Mechanical Addendum M-1

Date: August 30, 2023

Project: **Centre For Addiction and Mental Health
Move Consolidation – Interior Renovations**
250 College Street,
Toronto, Ontario,
M5T 1R8

Subject: Mechanical changes and/or additions

01 NEW LAYOUT - GROUND FLOOR (SOUTH) PLAN
M-201 1/8"=1'-0"

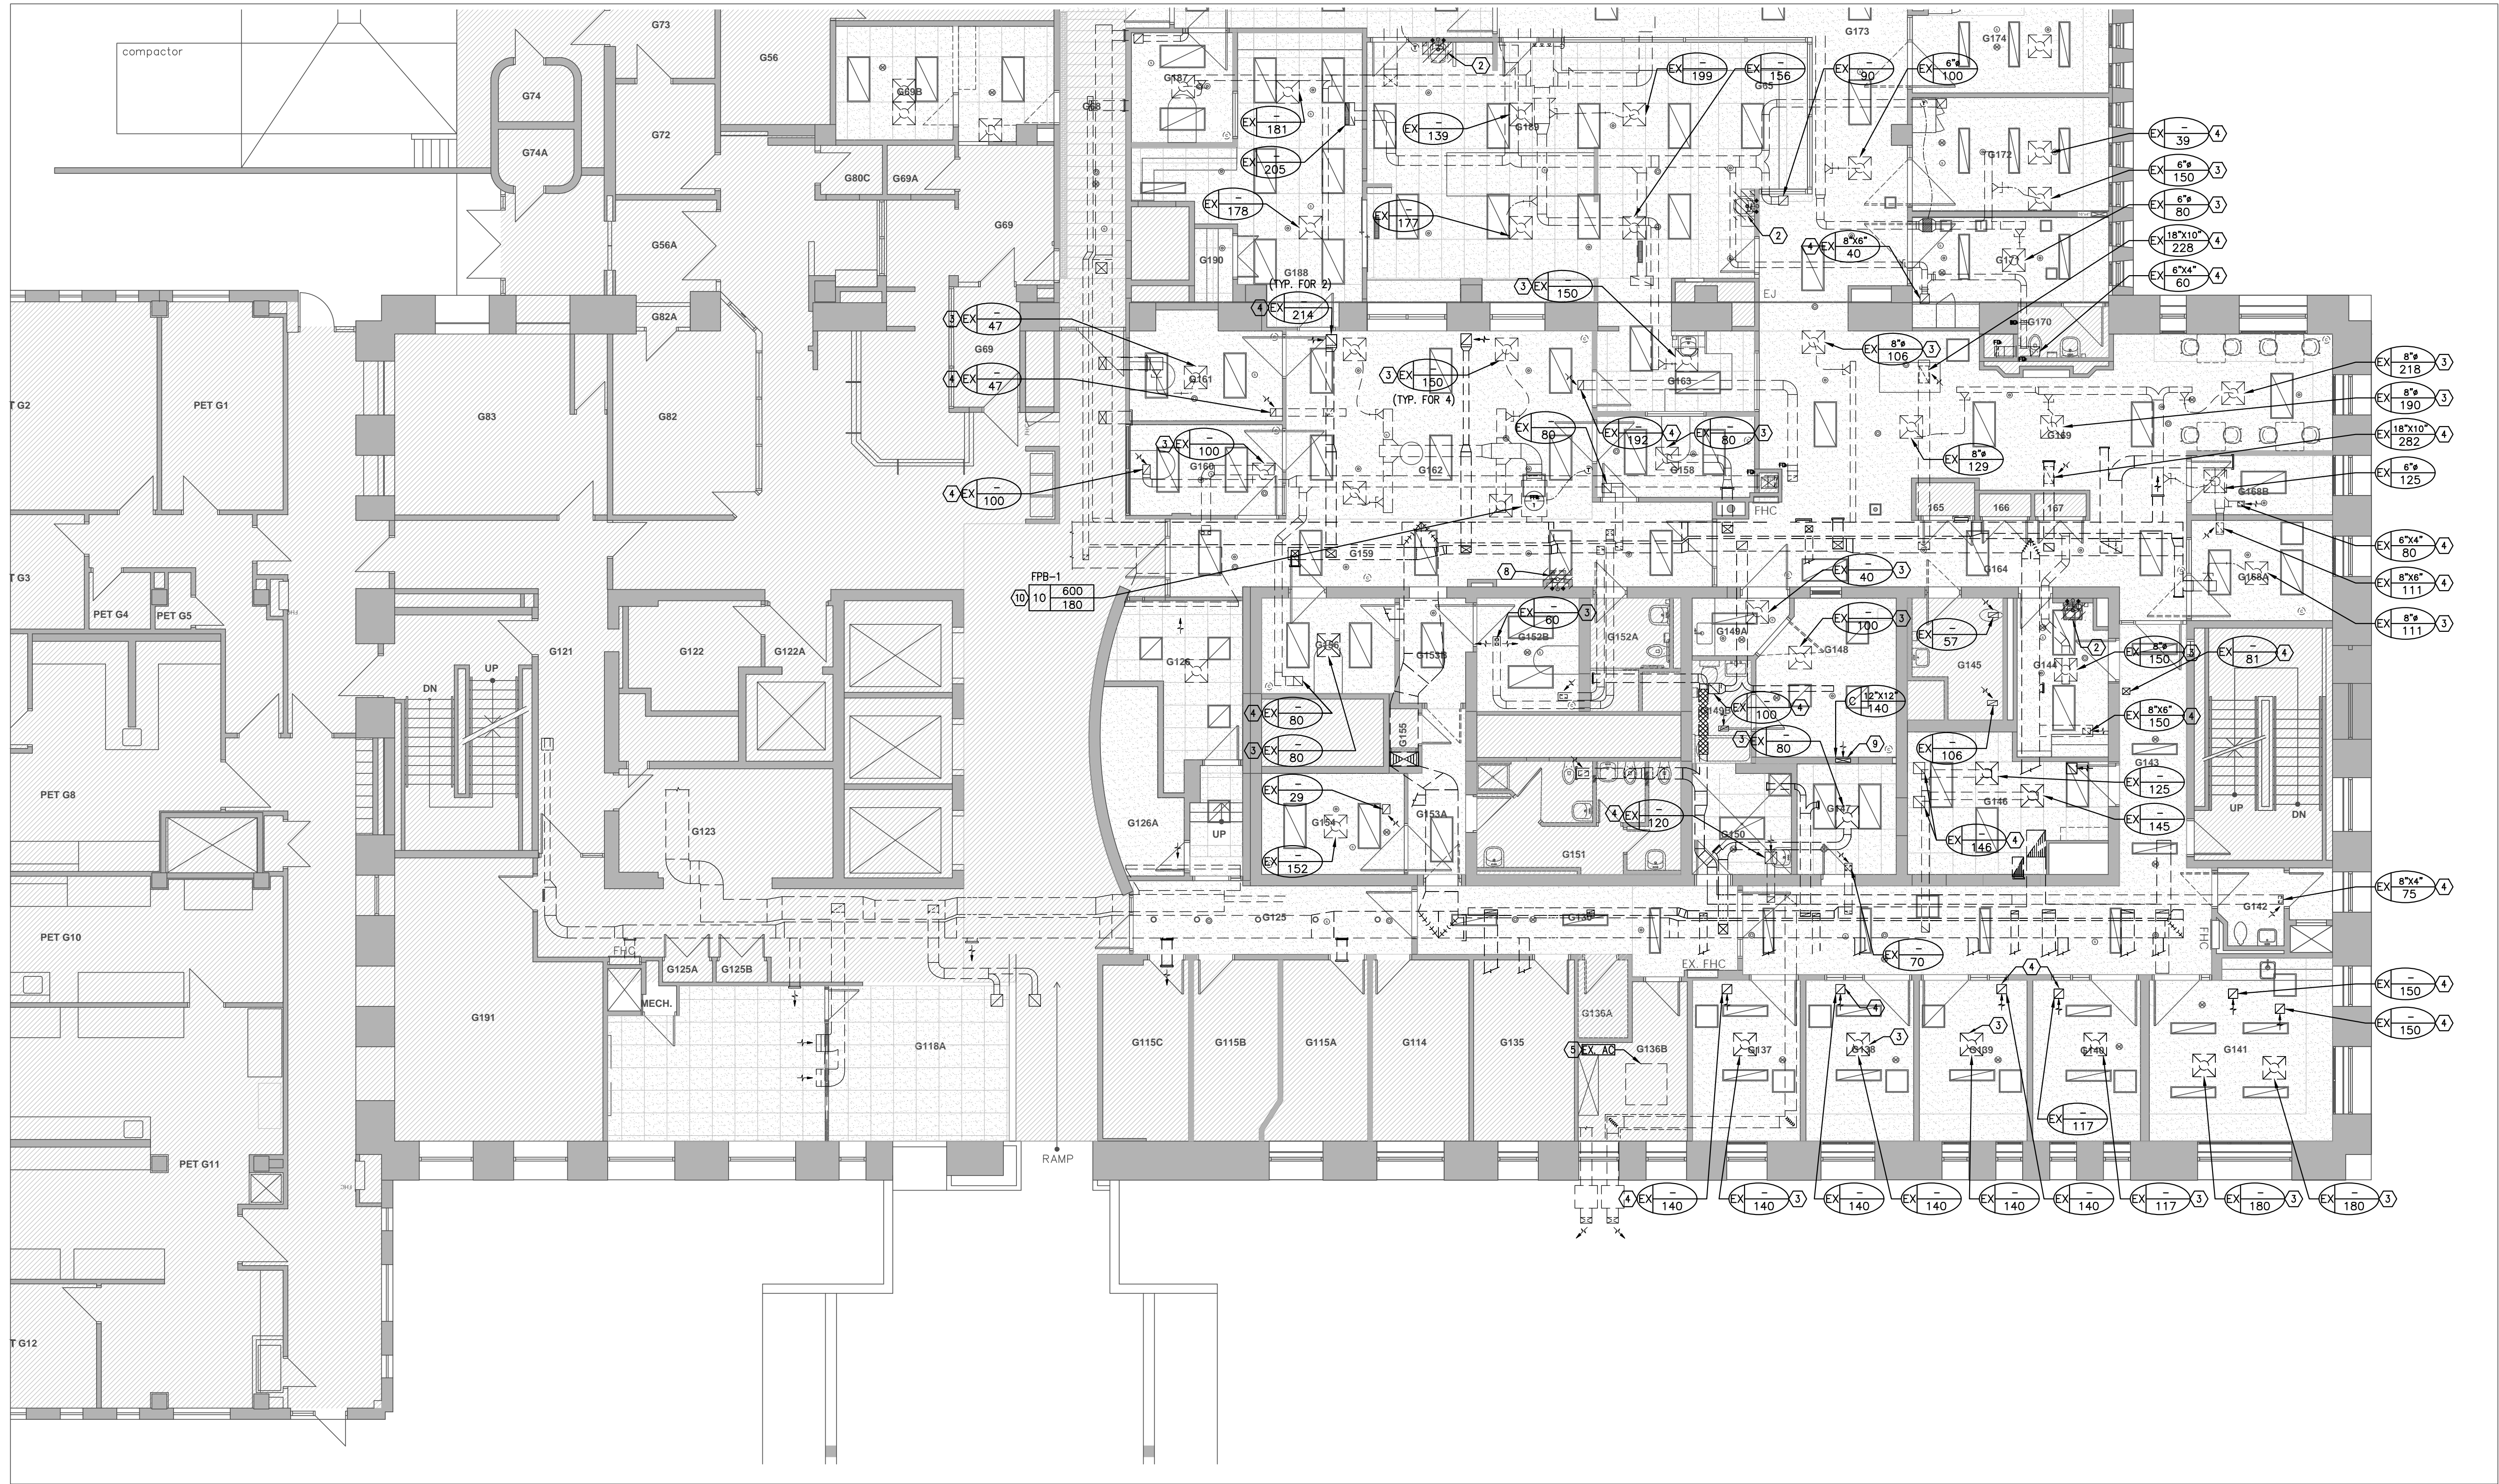
5. **Drawing M-201, Mechanical Plan – Ground Floor South Plan (Issued)**
 1. General Revisions have been made to the mechanical drawing. Refer to drawing notes.

01 DEMOLITION PLAN - ELEVENTH FLOOR PLAN
M-202 1/8"=1'-0"

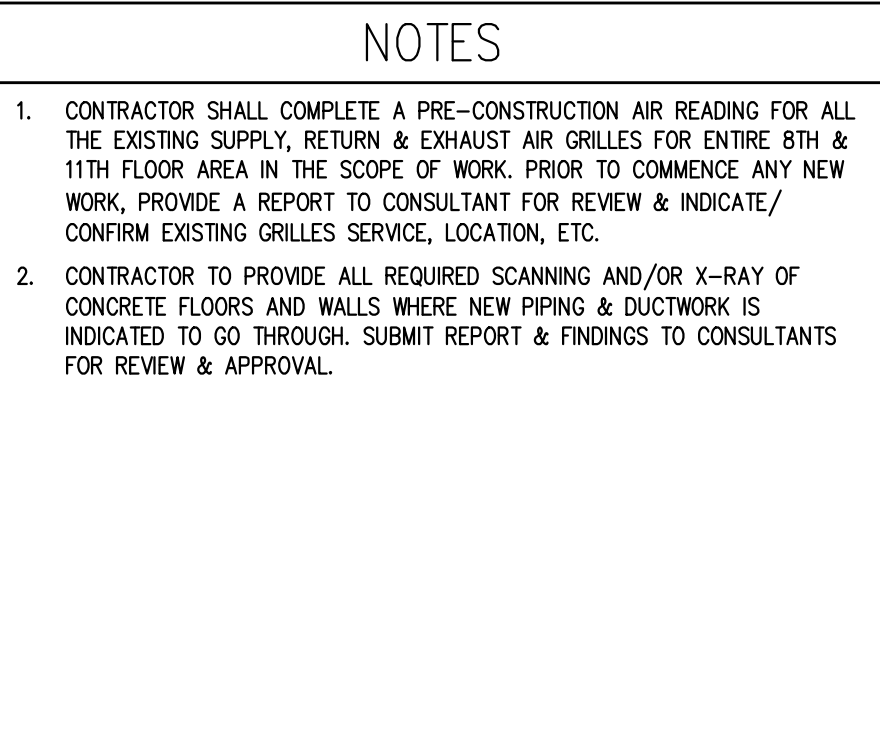
6. **Drawing M-202, Mechanical Demolition Plan – 8th & 11th Floor (Issued)**
 1. General Revisions have been made to the mechanical drawing. 11th floor demolition plan has been added. Refer to Drawing Notes.

Sheet Title:
**MECHANICAL DEMOLITION
 PLAN - 9TH & 10TH FLOOR
 PLAN**

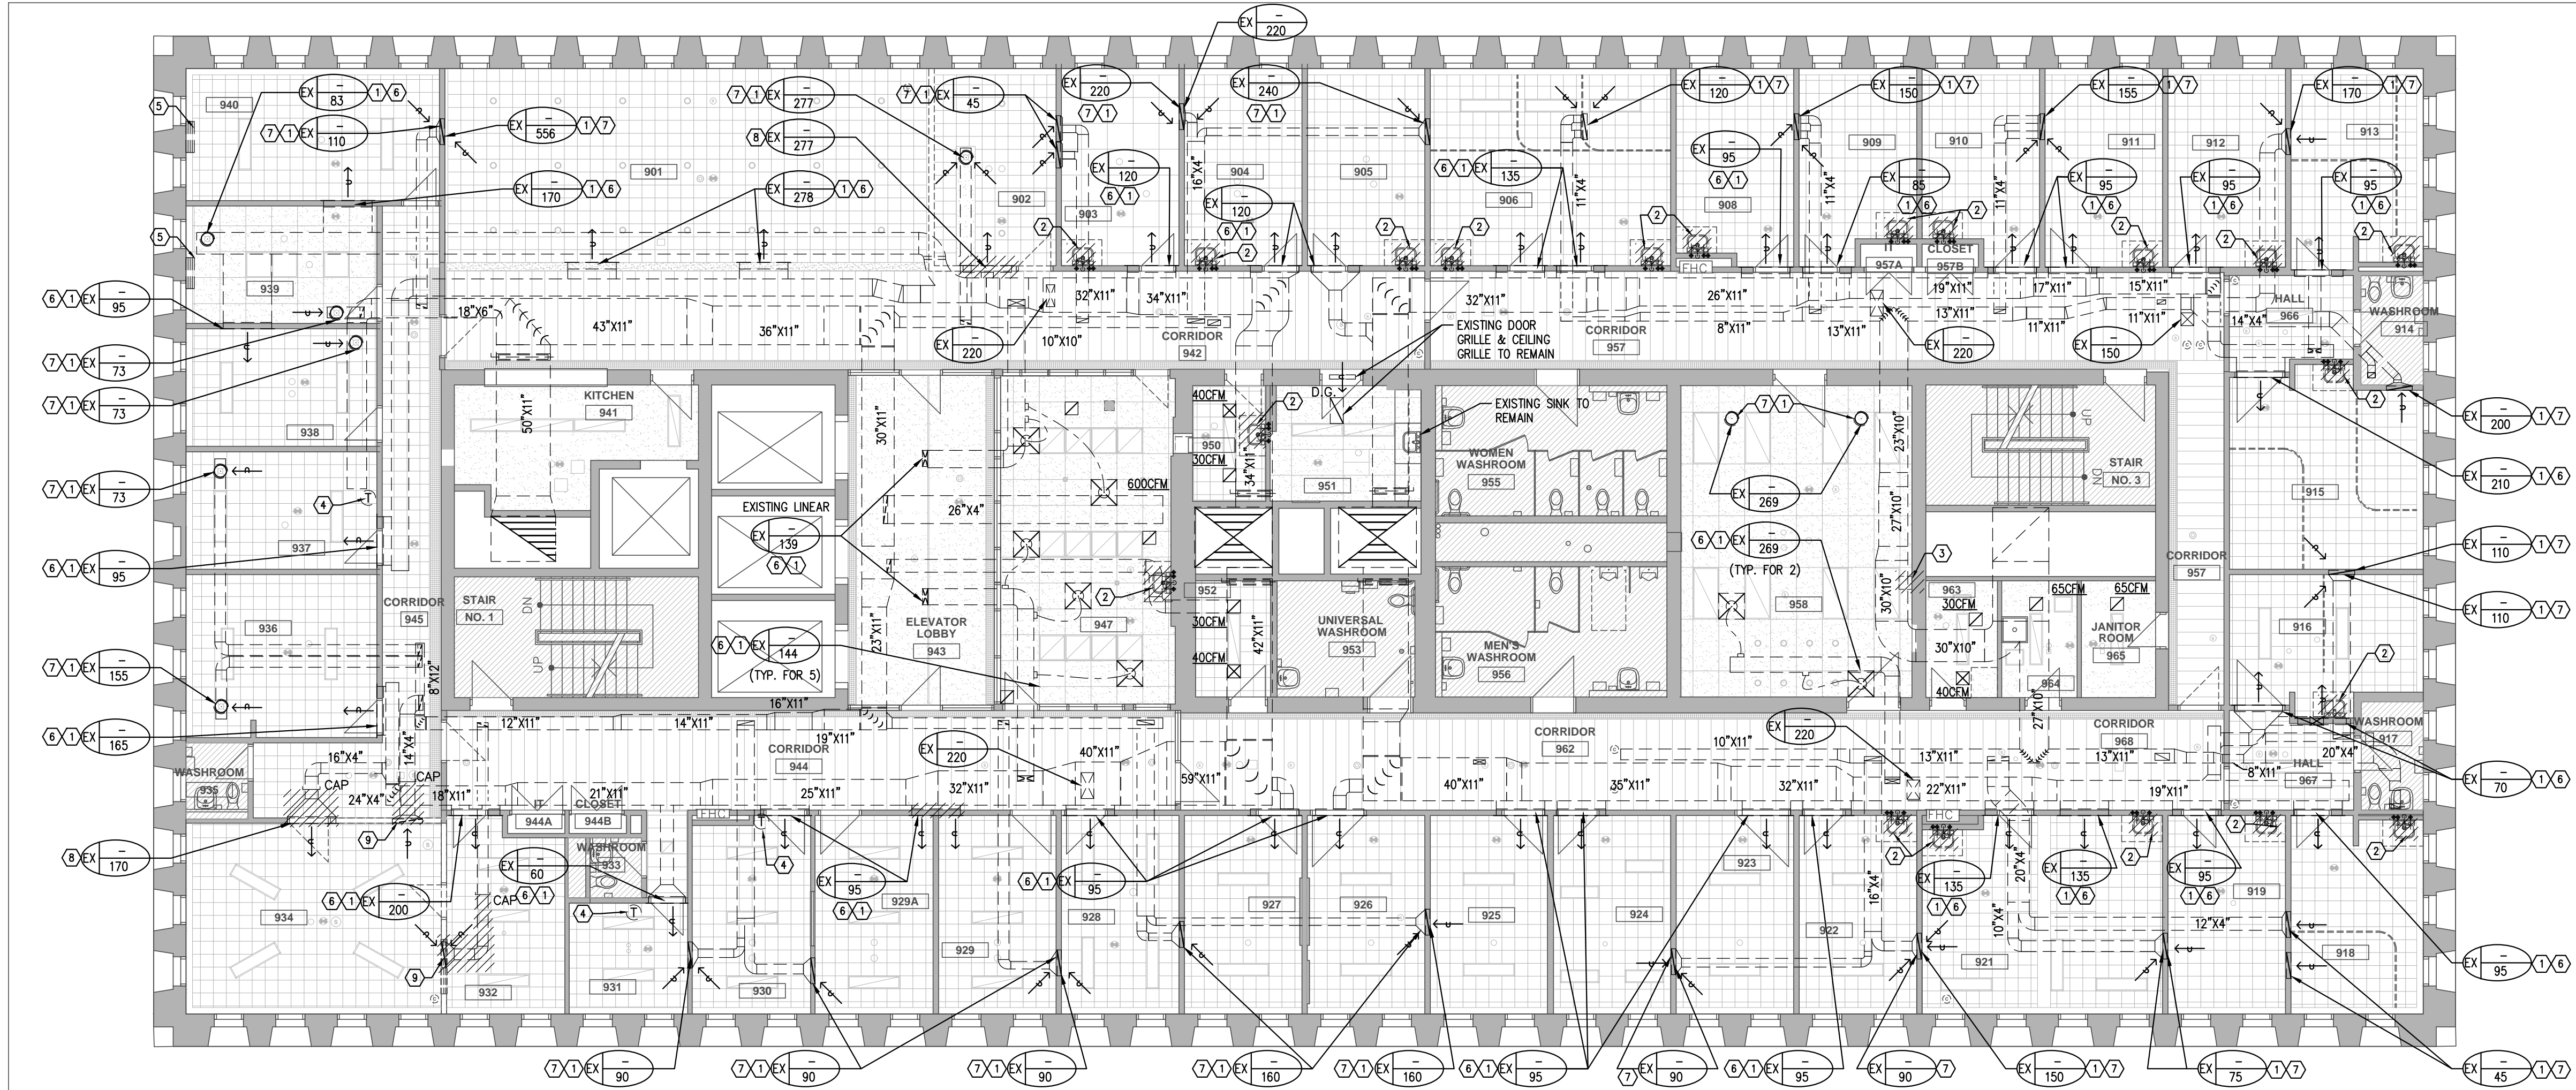
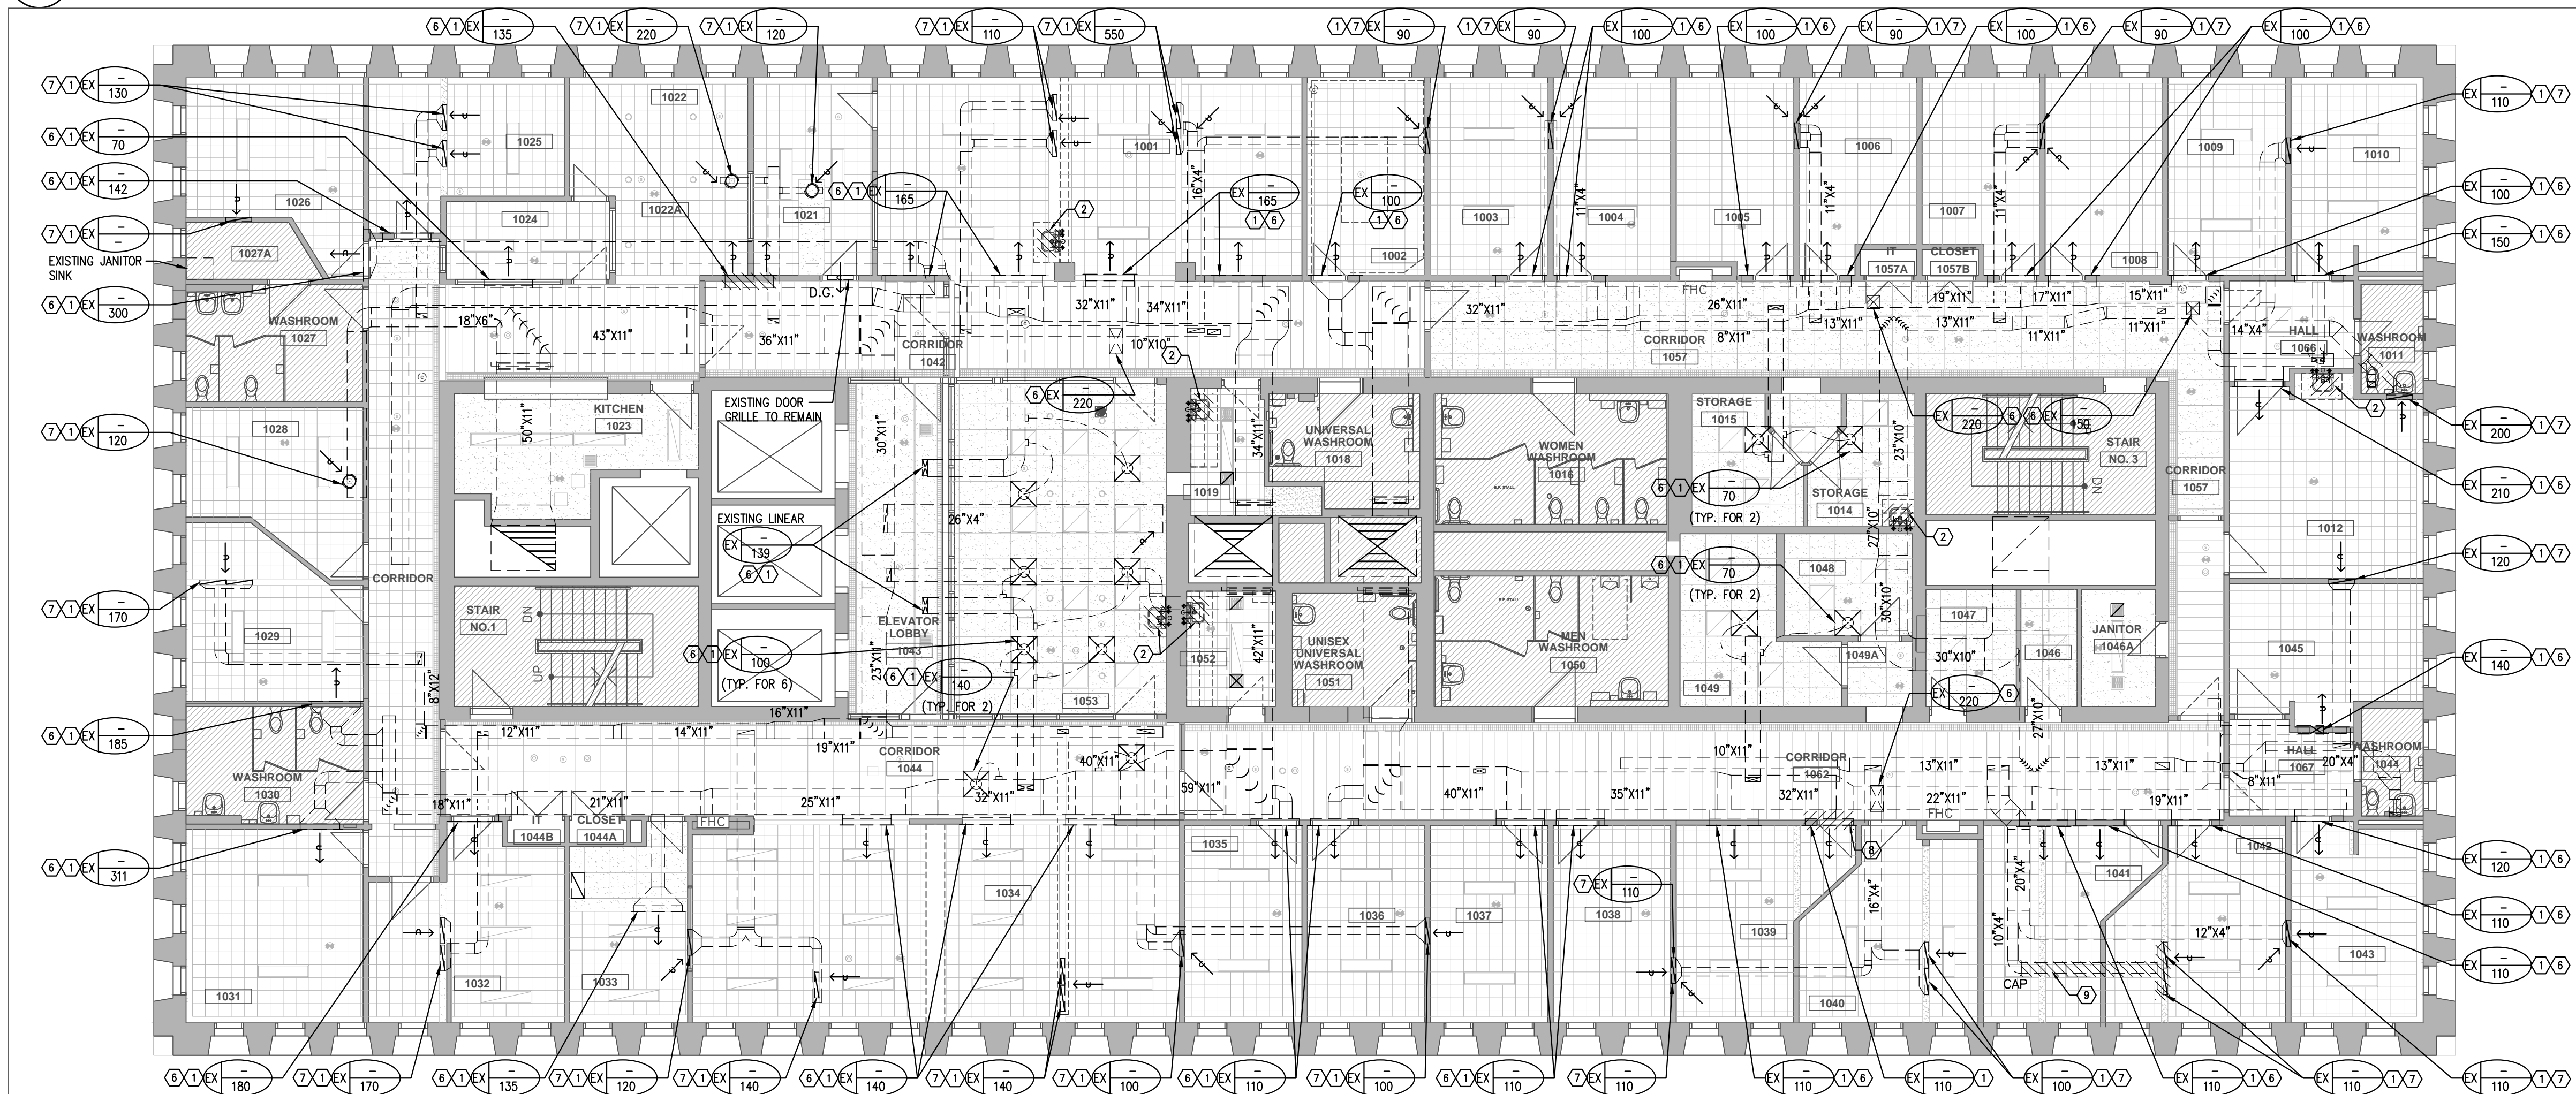
7. **Drawing M-203, Mechanical Demolition Plan – 9th & 10th Floor (Issued)**
 1. General Revisions have been made to the mechanical drawing. Refer to Drawing Notes.
